MEMORANDUM FOR RECORD

April 10, 2015

**SUBJECT:** DREDGE PRISM MODIFICATION AND VOLUME REVISION FOR NAVAL AIR STATION (NAS) WHIDBEY ISLAND FUEL PIER (NWS-2013-245), ISLAND COUNTY, WASHINGTON, FOR UNCONFINED OPEN-WATER DISPOSAL AT THE PORT GARDNER NON-DISPERSIVE DISPOSAL SITE.

Figure 3 - 2015 Final Design

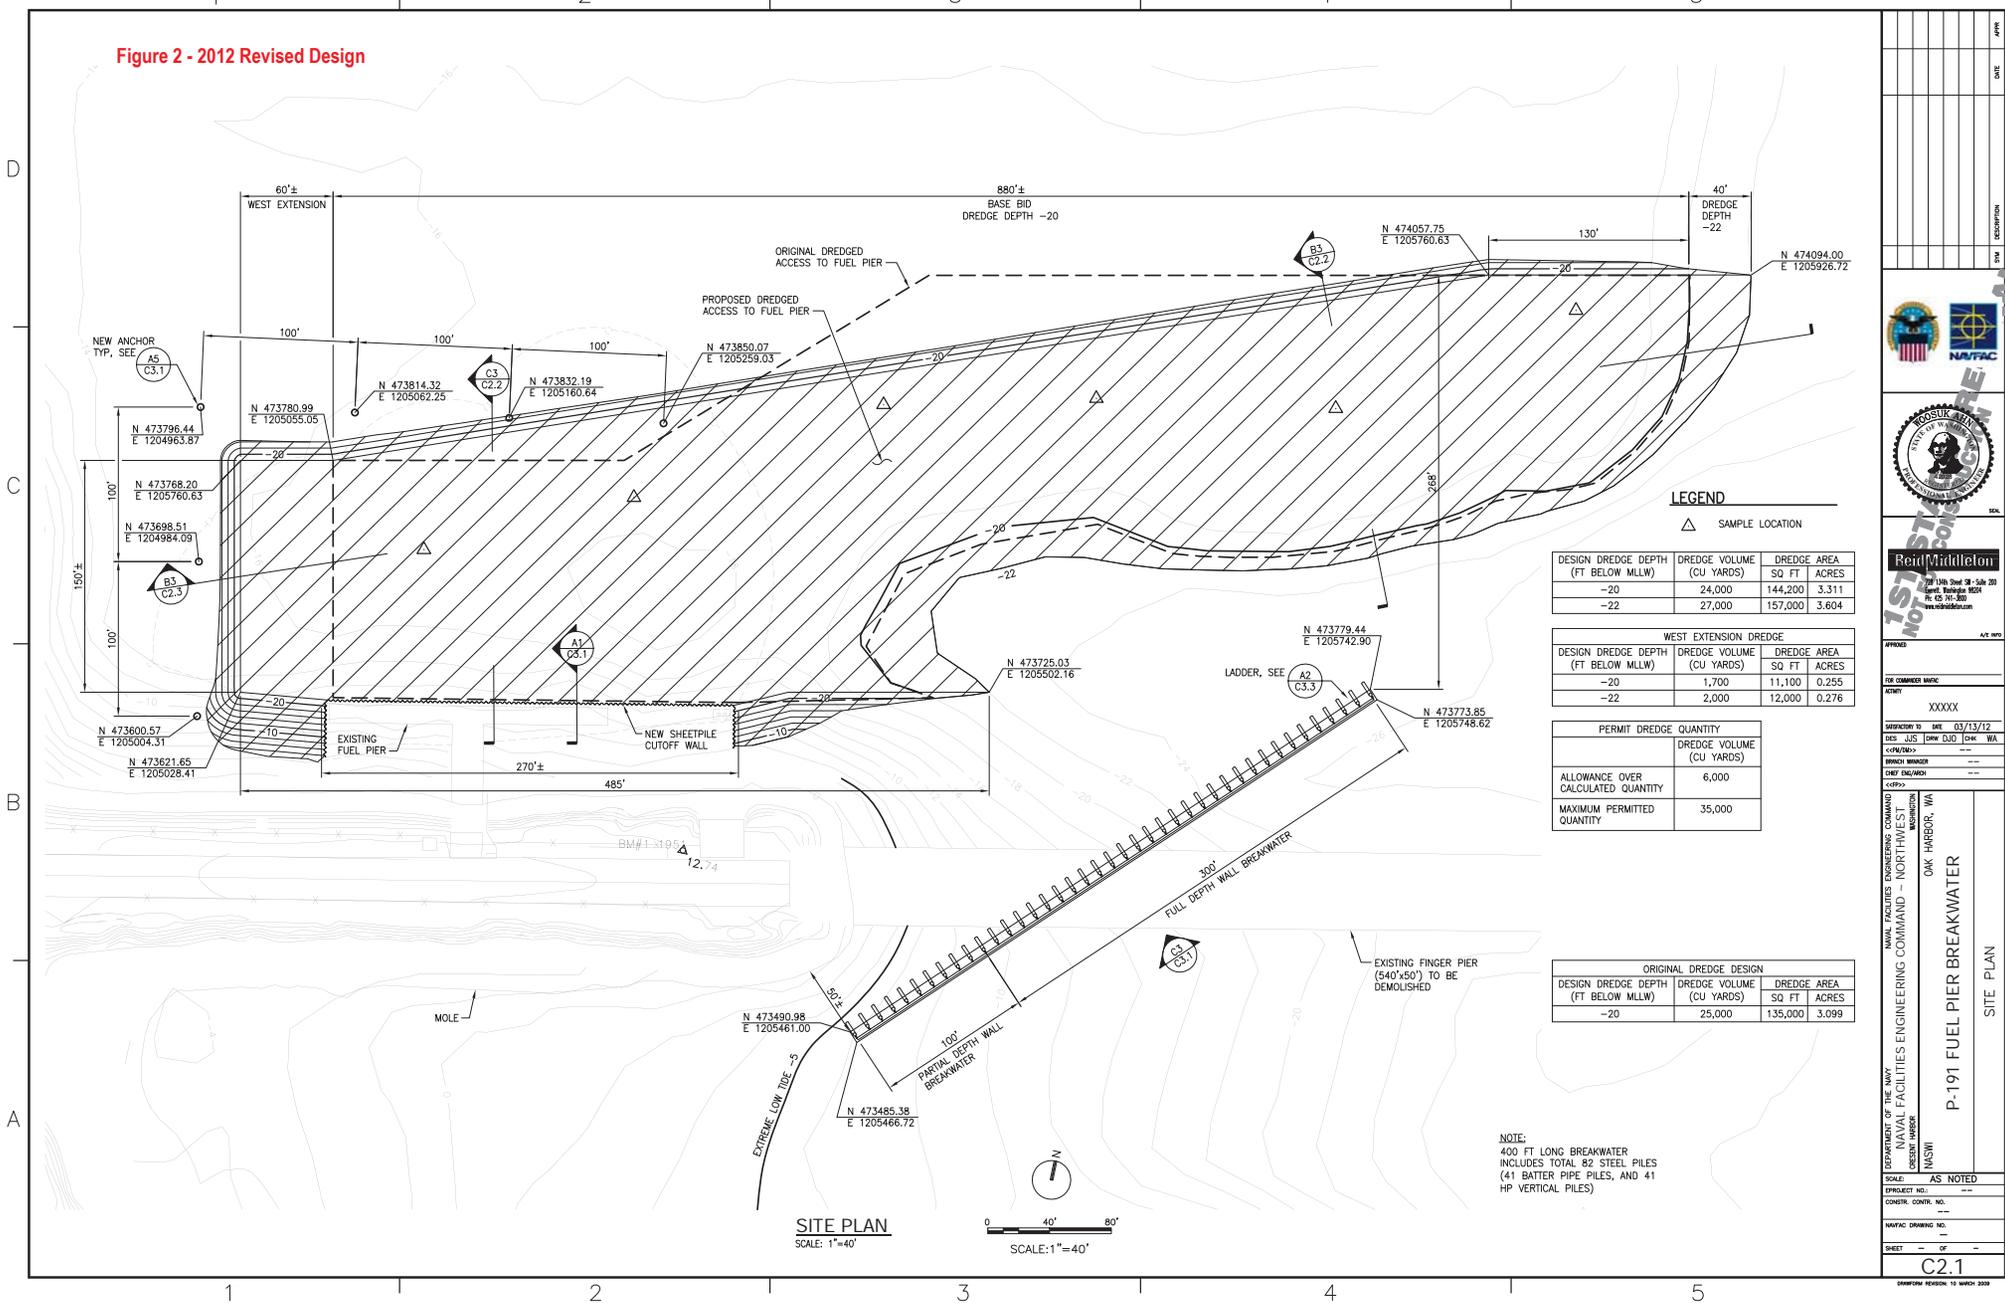
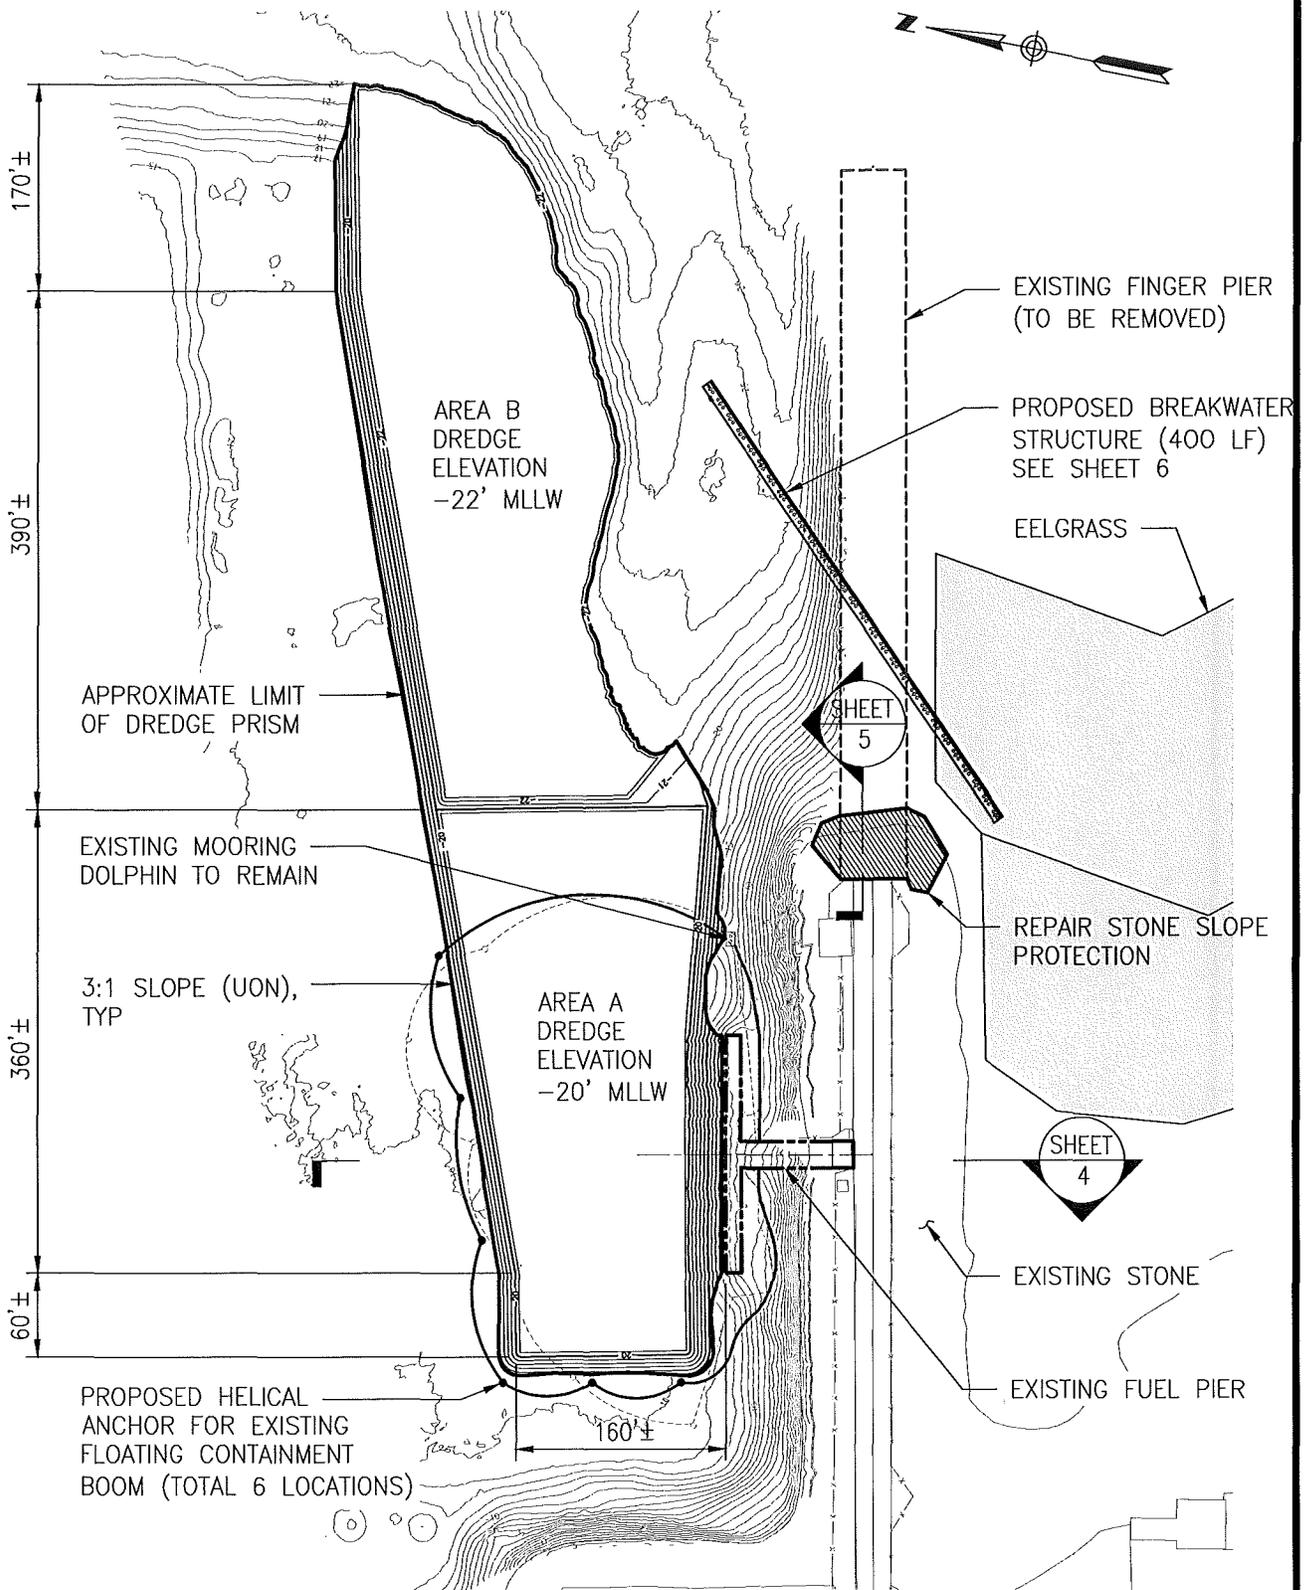
In March 2015 the Navy submitted a final design to the DMMP agencies for review. The final design included three key changes: a) the sheetpile wall that had been included at the face of the fuel pier in the 2012 design was removed; b) the toe of the side slope of the dredge prism was pulled away from the face of the fuel pier by approximately 35 feet; c) the overdredge depth was increased from 1 foot to 2 feet. The 2012 design is shown in Figure 2. The final design is shown in Figure 3.

3. The DMMP agencies reviewed the 2015 design modifications vis-à-vis the 2011 suitability determination and the 2012 design-revision memorandum and concluded that additional sampling and testing would not be required for the following reasons:
  - The dredged material footprint is essentially the same as in the 2012 design.
  - The toe of the dredge prism side slope has been pulled away from the face of the fuel pier such that the top of the side slope daylights at the face of the pier. Based on this design change and the lack of steep-sloped sediment under the pier, the Navy predicts that sloughing of material from under the pier will not occur during dredging. While there is no evidence that the sediment under the pier has any higher level of contaminants than the sediment in the rest

of the dredge prism, in the event the under-pier sediment were more contaminated, the final design minimizes the potential for under-pier material to slough and be dredged and disposed at the Port Gardner site.

- The additional material included in the volume estimate is from an increase in the overdredge depth, plus application of a 10% contingency factor. The 2012 design revision memorandum documented that most of the deeper material is native. Therefore, the additional foot of overdepth included in the final design is mainly native material, in which levels of contamination are anticipated to be lower than in the overlying maintenance-dredged material.

Attachment 1  
Figure 3 - Revised Dredging Plan

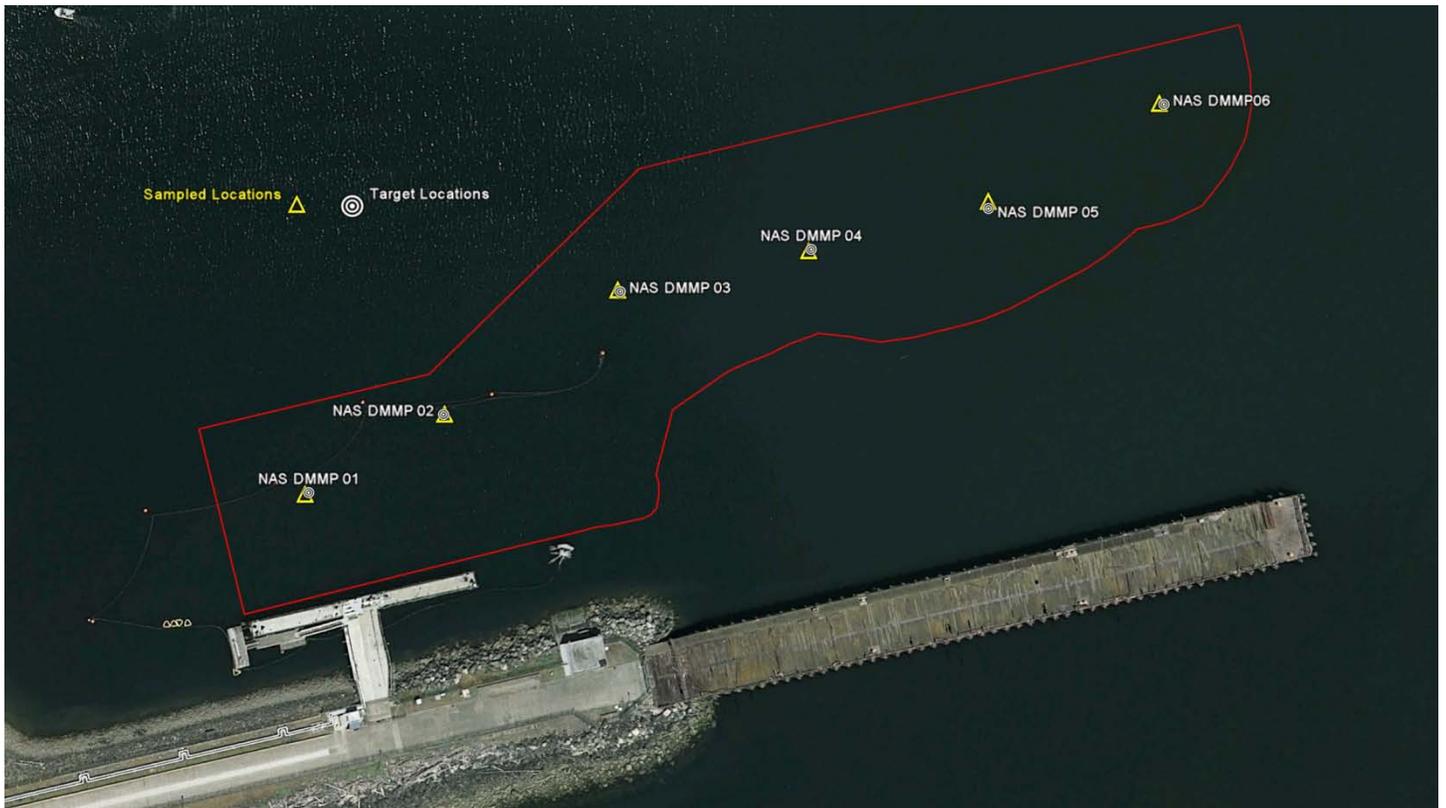
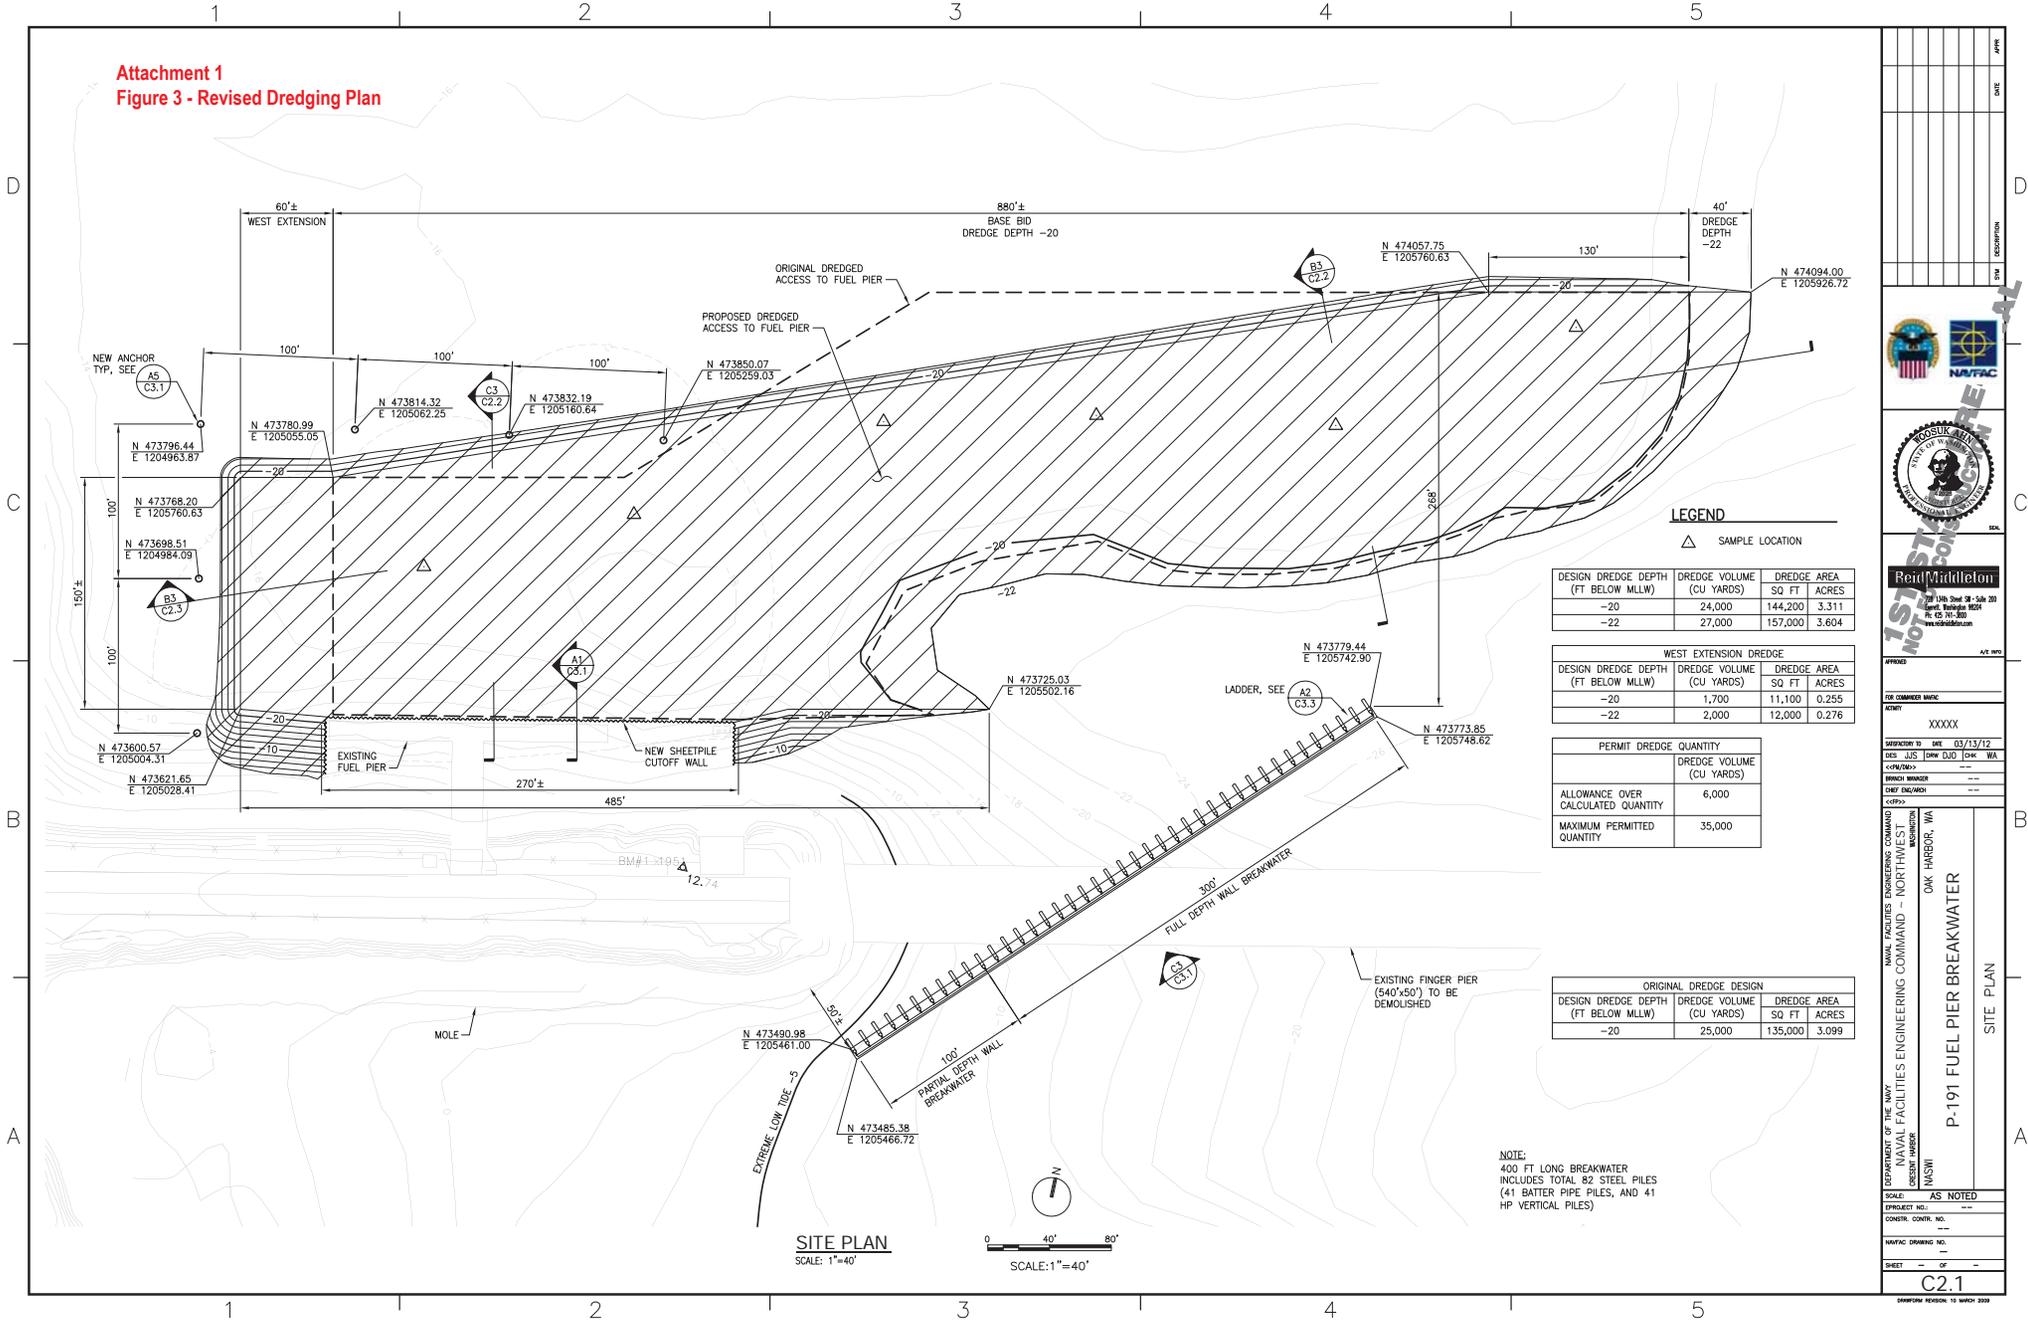
2. Subsequent to the 20 May 2011 suitability determination, the Navy made revisions to the project design. Figure 2 shows the footprint of the original dredging plan and the six sampling stations used in the DMMP characterization of the project. Figure 3 shows the modified design. For reference, Figure 3 also includes the footprint of the original design and the six DMMP sampling stations. As can be seen, the modified design includes minor changes in the footprint of the project, plus a 60-foot extension on the west end of the project. The design depth may also change. The original design depth was -20 feet MLLW (plus 1-foot of overdredge depth), but the Navy would like to include a bid option for an additional two feet of dredging for a revised design depth of -22 feet (plus 1-foot of overdepth). To cover this contingency the Navy has requested a volume increase to a maximum of 35,000 cy.

- The sampling stations used in the 2011 DMMP characterization fall within the footprint of the modified project and provide adequate spatial representation of the modified project.

- Stiff inorganic clay (i.e. native material) was encountered at stations DMMP-1, 2, 3 and 4. This prevented z-samples from being collected at DMMP-1, 2 and 3; only a 0.6 ft z-sample could be collected at DMMP-4. The z-samples collected at DMMP-5 and 6 were silty sand, but these two sampling locations are the farthest removed from the fuel pier. Therefore, most of the deeper material in the modified -22-foot project is native material.

- While the revised dredging boundaries now include the sideslopes on either end of the sheetpile wall at the face of the fuel pier, the volume to be dredged from these sideslopes is estimated to be only 358 cy, approximately 1 percent of the total volume. The sheetpile wall will be in place prior to dredging, thereby preventing underpier material from sloughing into the area being dredged.
